RE: Planning Application 2024/3069/P – 24 Burgess Hill, NW2 2DA

I am writing to **OBJECT** to certain elements of the above applications on planning grounds, specifically:

1. Location of proposed ground level infill extension

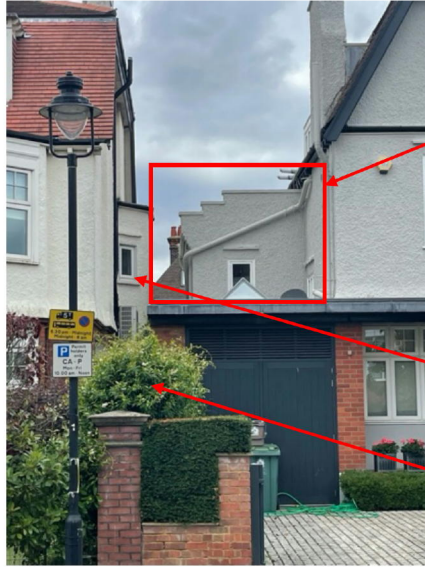
Area of proposed ground level infill extension looking down from first floor window. The photo illustrates the exceptionally narrow gap between our houses at certain points at ground level, and which would be completely out of keeping if extended. An infill and first floor extension would severely restrict access to the side of our house, especially the chimney breast, for repairs and maintenance.

Window at ground level that would suffer significantly reduced natural light by construction of the proposed infill and extension.

Roof of Applicant's existing garden shed which encroaches upon and overhangs our land.
